Harmony Ranch Subdivision

Improvement Plans

WEBER COUNTY, UTAH

Cover/Index Sheet

3420 EAST STREET 10+50.00 - 14+00.00

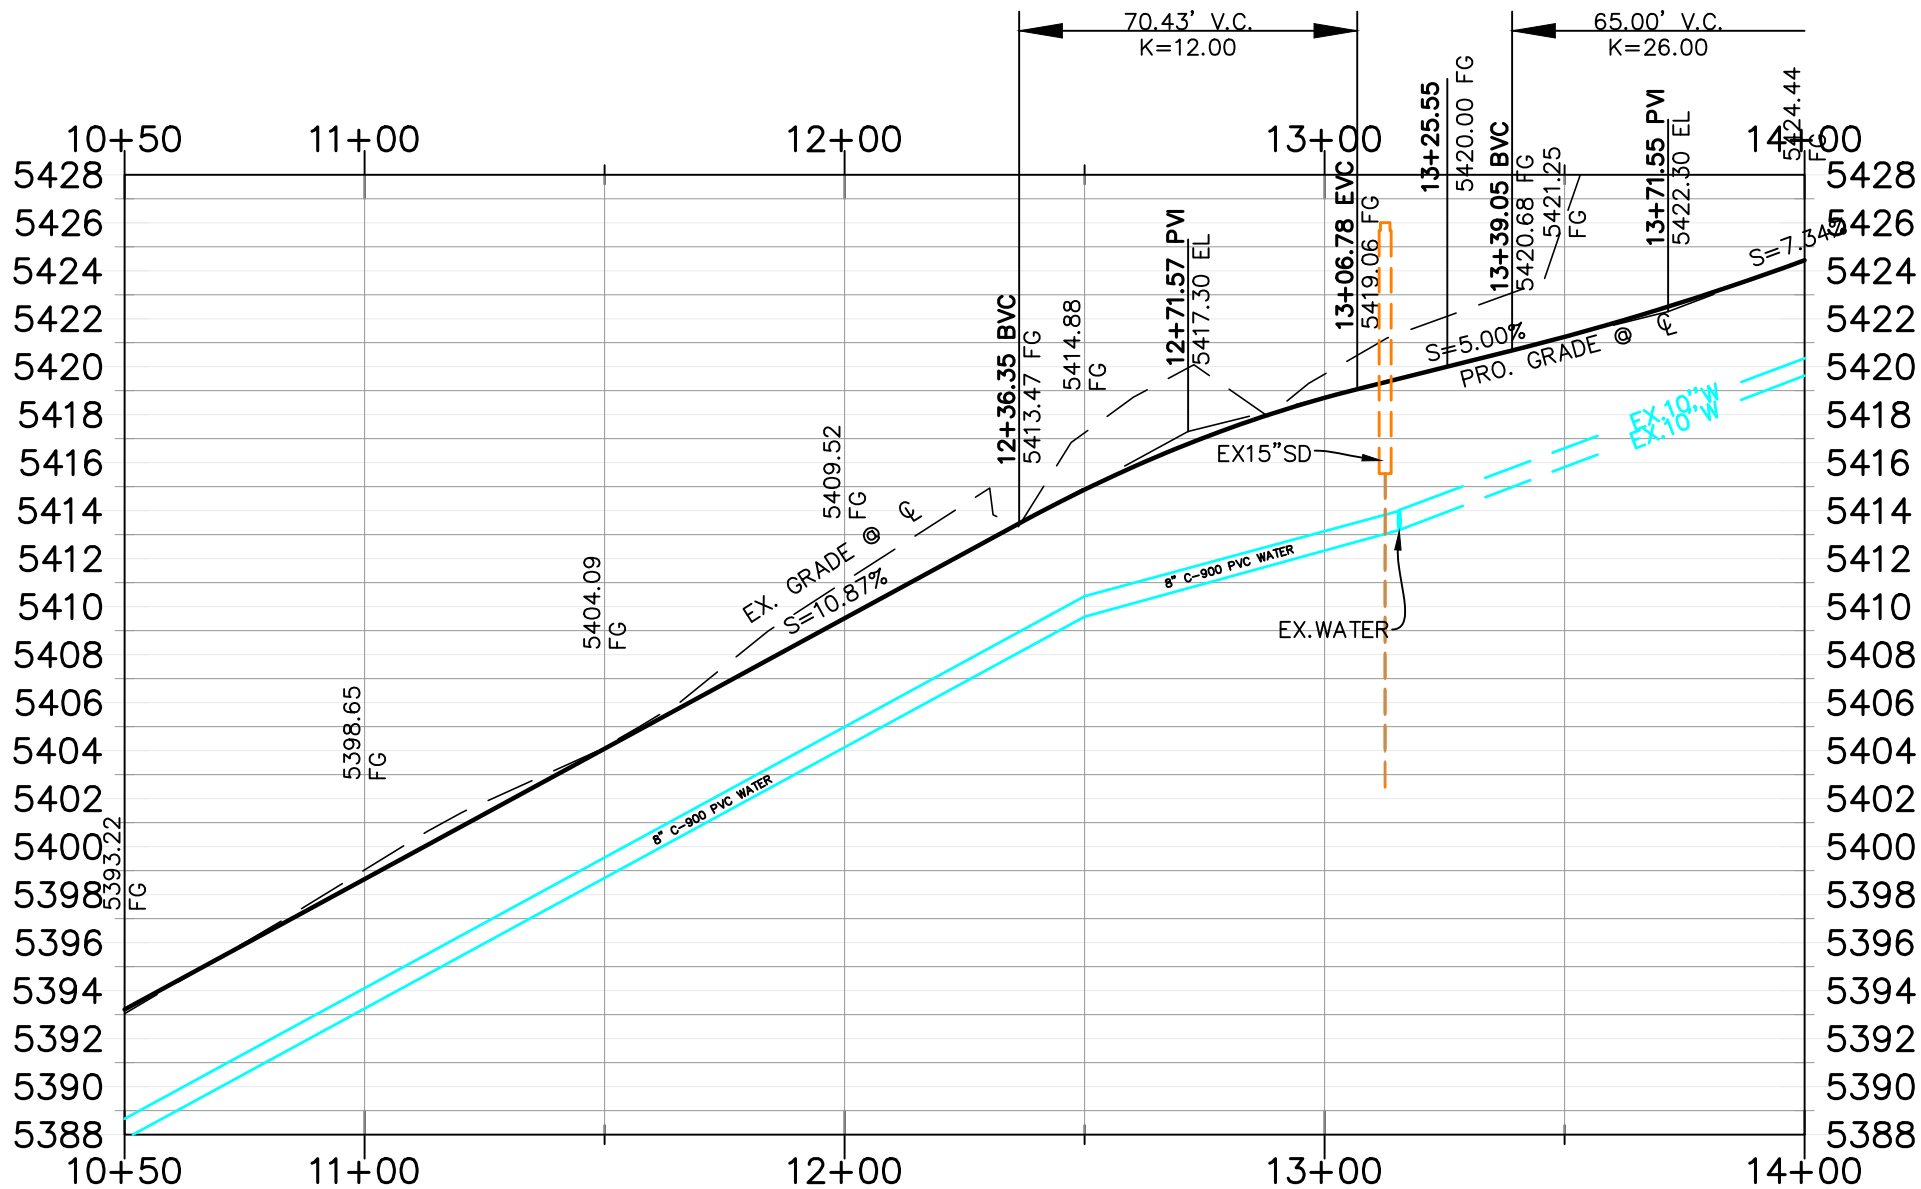
Where does the Storm Water go?

3070 NORTH STREET 1+00.00 - 6+00.00

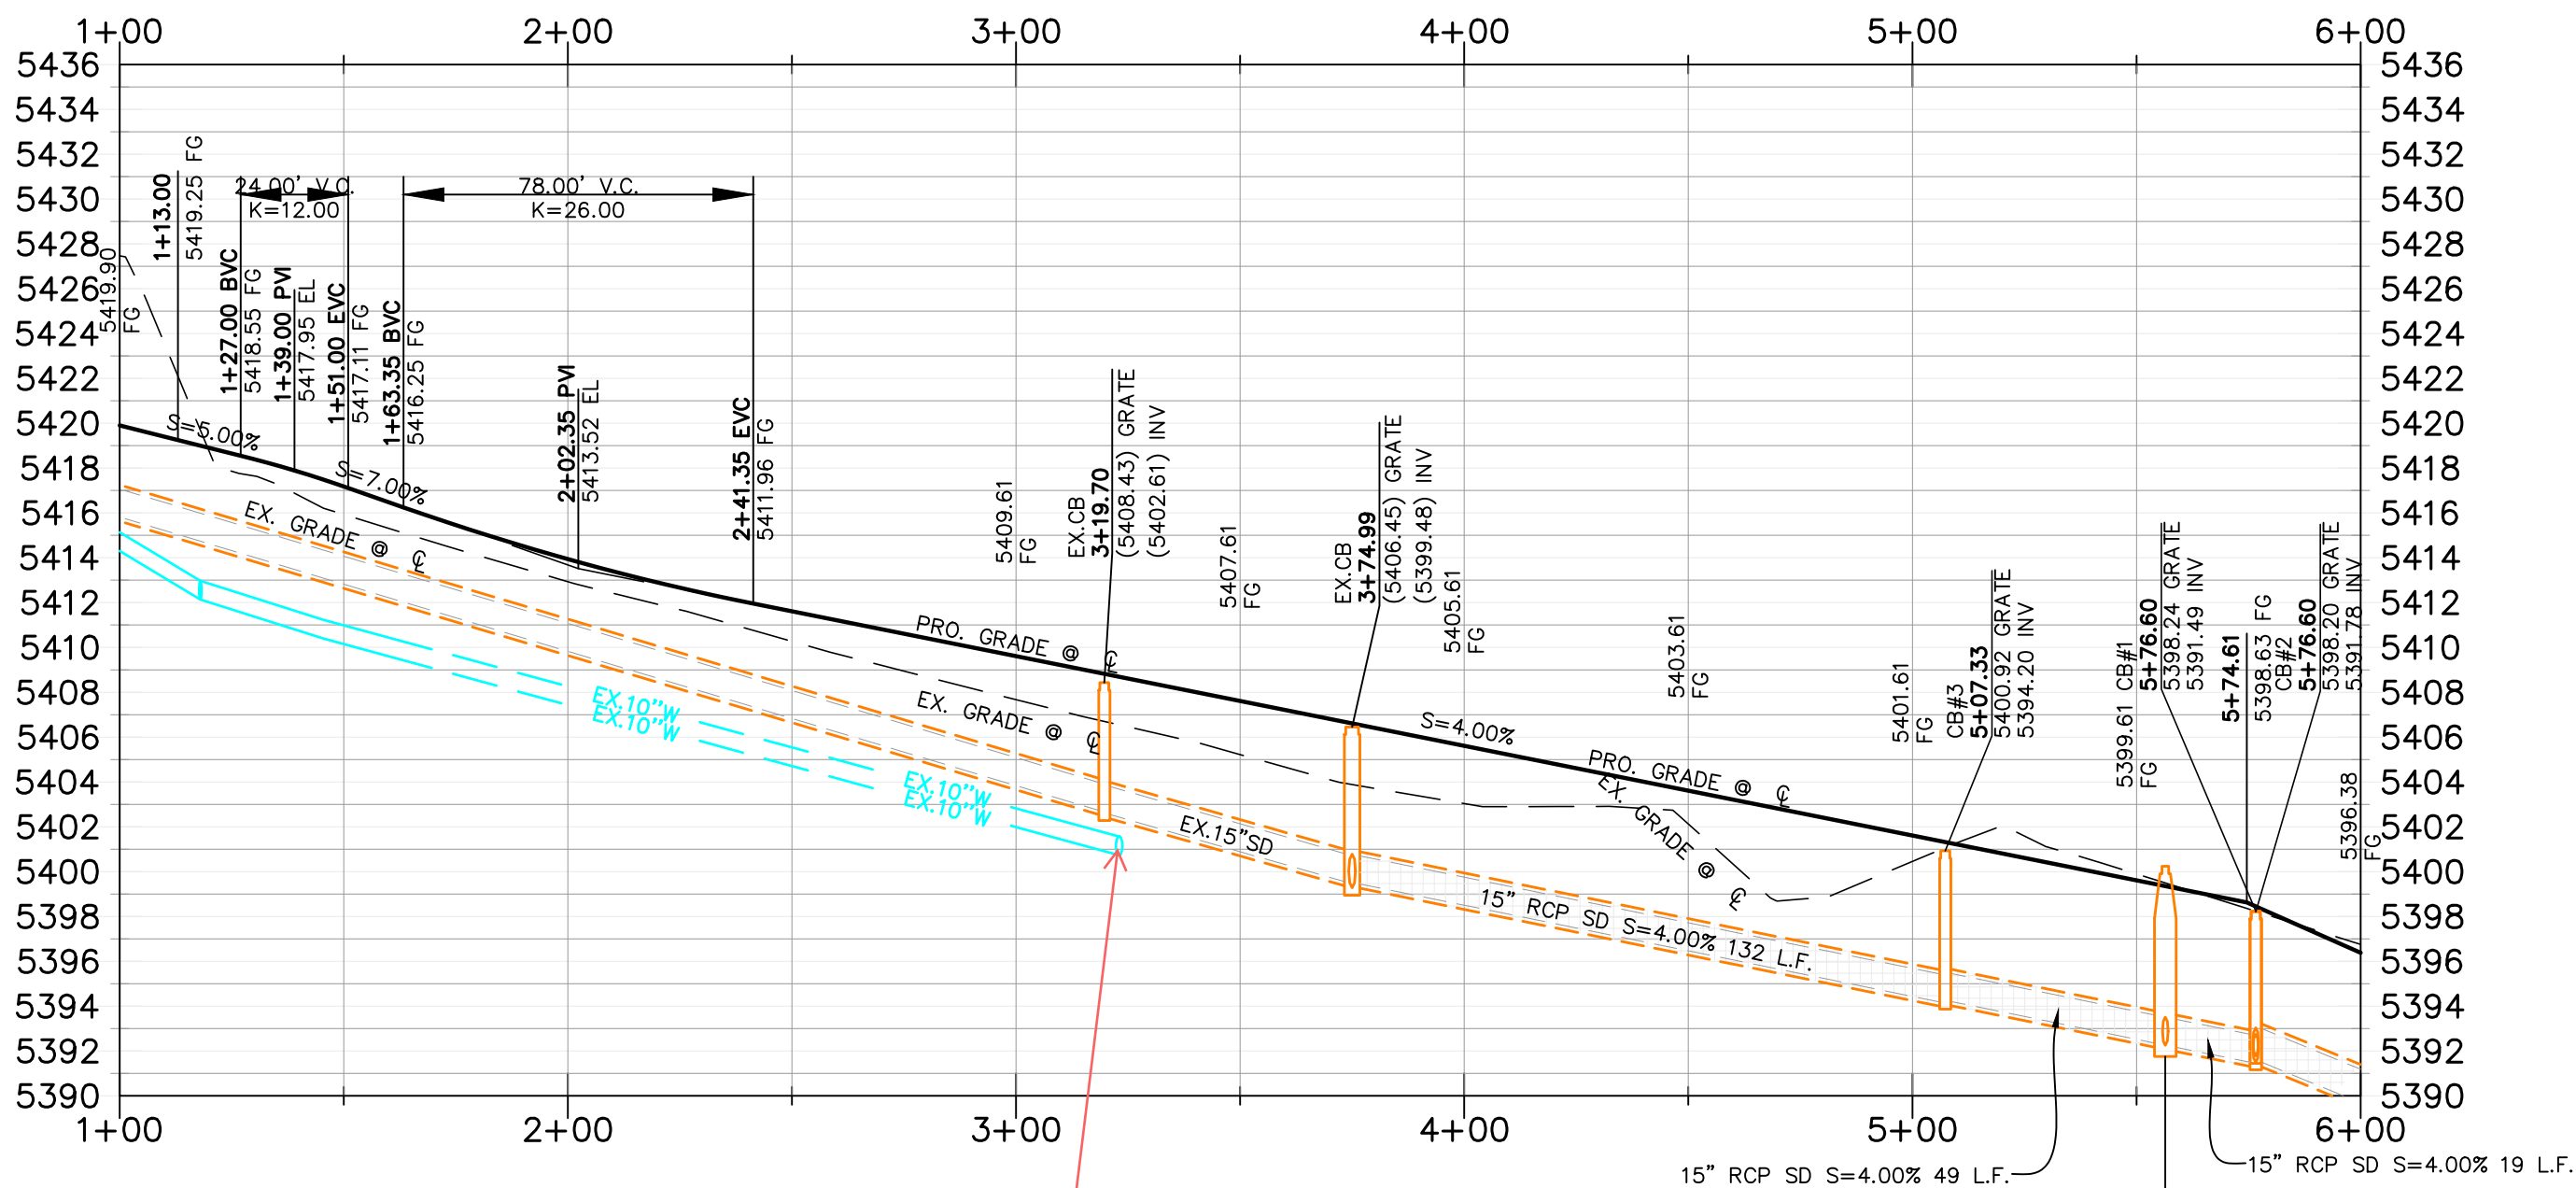
Does this water line stop?
